Docket Item #8
BAR CASE #2005-0227

BAR Meeting
October 19, 2005

ISSUE: Demolition and Encapsulation of Exterior Features

LOCATION: 211 Franklin Street

Figure 1 - Front areas of demolition and capsulation

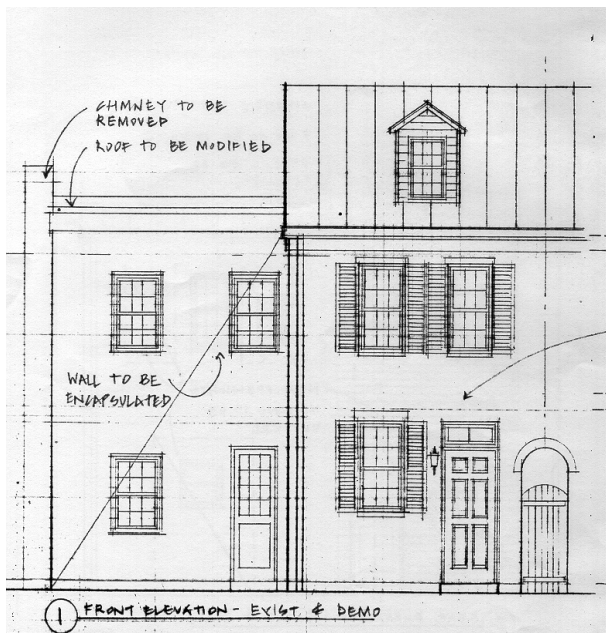
The features proposed for removal include raising approximately 16 linear feet of roof of the rear wing of the original portion of the house (160 sf in area), and removing a brick chimney on the exterior west wall of the 0 to the house. Also, substantial areas (approx. 84 sf.) of the existing walls of the later addition are to be removed to create new window or door openings.

Staff believes that criteria #1, 3, 5, & 6 are met as applied to the original portion of the house. Staff notes that small vernacular houses of this period are relatively uncommon in Alexandria. The roof of the original house which is proposed to be raised is likely to consist of original fabric. The original roof pitch in this area as re-built would also be altered from the original as well. The removal of substantial areas of original masonry on the rear or north elevation would alter irreversibly this portion of the house. Also, encapsulation of the west wall of the main house to the degree anticipated would further impinge upon the visible form and fabric of the west side of the earliest portion of the structure, a wall which clearly was constructed with the intent to be a finished and visible feature, despite the known, but undocumented appearance of a later structure which has since been removed.

Figure 2 - Rear areas of demolition

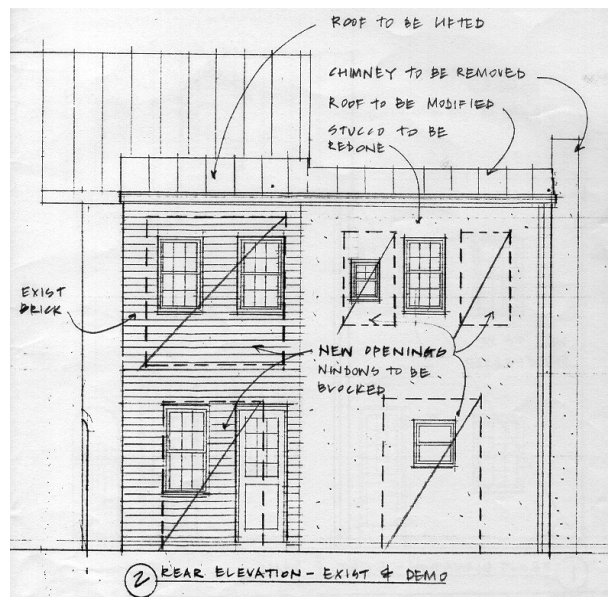
Approximately 93 sf. of the rear wall of the original wing are proposed to be removed in order to create two large openings in this small wall surface.

Figure 3 - Side areas of demolition and capsulation

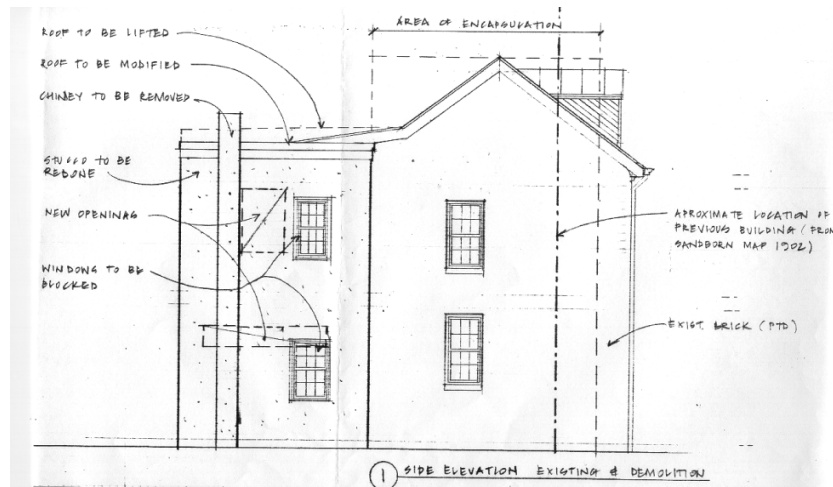
Review of the Criteria for Demolition demonstrate than none of the features proposed for removal or encapsulation on the two story side addition merit retention. A building permit from 1951 indicates that numerous alterations to the addition were completed, including reconstruction of the north (rear) wall, reconstruction of the chimney and raising the overall height of the addition to increase ceiling heights on the second story (permit #9858, 8/29/51).
